Florida Department of Environmental Protection

January 31, 2007

Thank you for your January 3, 2007, request to revise the *Everglades Protection Area Tributary Basins Long-Term Plan for Achieving Water Quality Goals* (Long-Term Plan). The Department appreciates your efforts to implement the adaptive implementation approach envisioned in the Long-Term Plan, which will greatly enhance Florida's efforts to restore and protect the Everglades ecosystem.

Figure 2 – Schematic of L-8 CERP Project

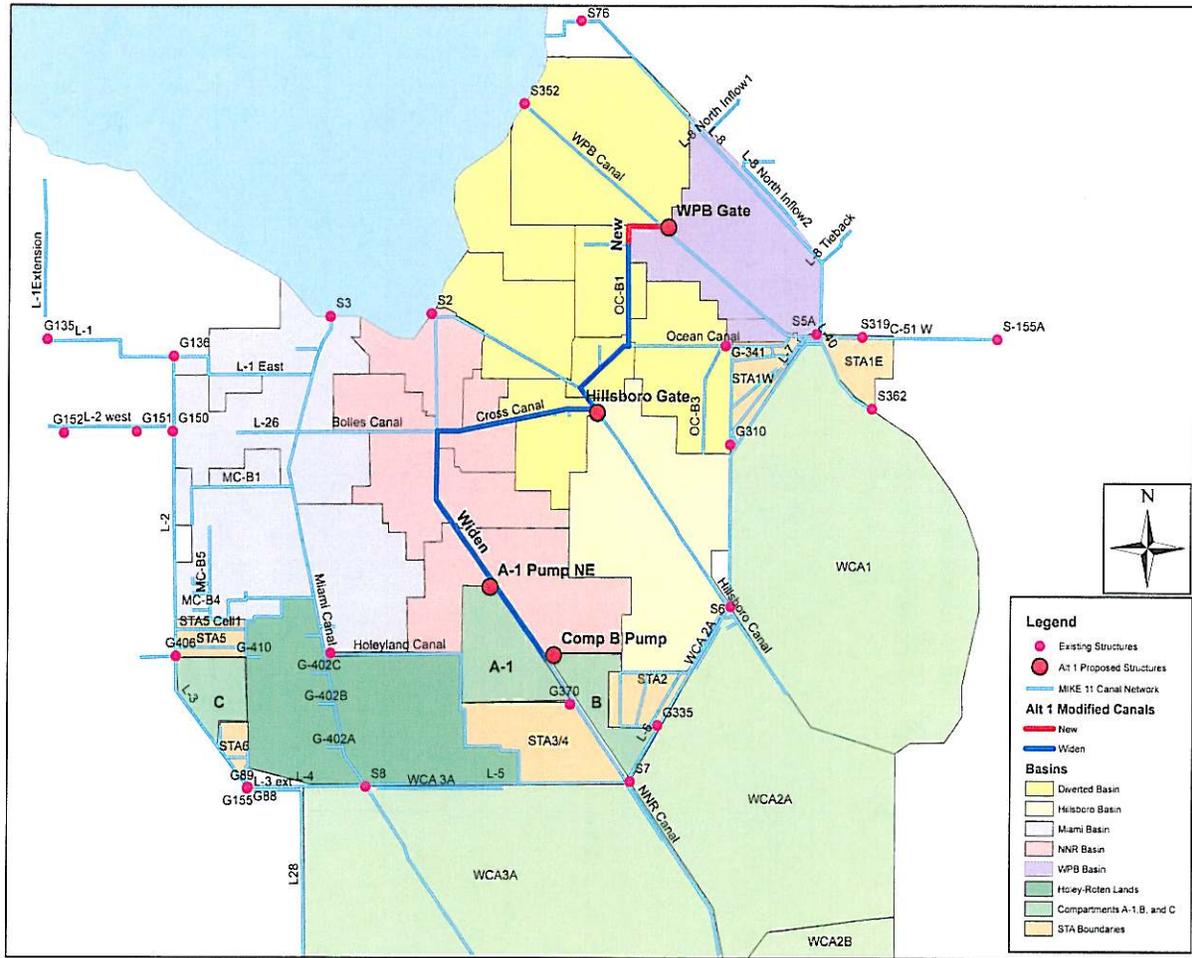
2. Integration of the L-8 Basin Comprehensive Everglades Restoration Plan (CERP) Project (Figure 2) into the Long-Term Plan. This project is consistent with the intent of the Legislature that "implementation of the Long-Term Plan shall be integrated and consistent with the implementation of the projects and activities in the Congressionally authorized components of the CERP so that unnecessary and duplicative costs will be avoided" (Section 373.4592(3)(c), Florida Statutes). A fundamental assumption of the Everglades Construction Project and EAA Regional Feasibility Study is that L-8 Basin runoff will be diverted away from the Stormwater Treatment Areas to ensure their proper operation. The preferred alternative is to expedite the CERP L-8 Basin Project by using Long-Term Plan funding to assist with the implementation of the inflow structure and/or outflow pumps in FY2007. The conceptual schedule for this project as documented in the Restudy, i.e. the Yellow Book, showed construction starting in approximately 2008. By providing FY2007 Long-Term Plan funding, the L-8 Project can be started earlier than the original schedule. By starting to send L-8 Basin runoff into the reservoir, large runoff events will be attenuated in the reservoir and phosphorus uptake will occur. Although it is difficult to quantify the precise amount of phosphorus that will be removed, some phosphorus reduction benefit can be anticipated. The amount of Long-Term Plan funding to be initially provided in FY2007 is \$1 million, with an additional \$1 million to potentially be provided later in FY2007 if CERP funding is not available and the funds are needed to maintain the expedited L-8 Basin Project schedule.
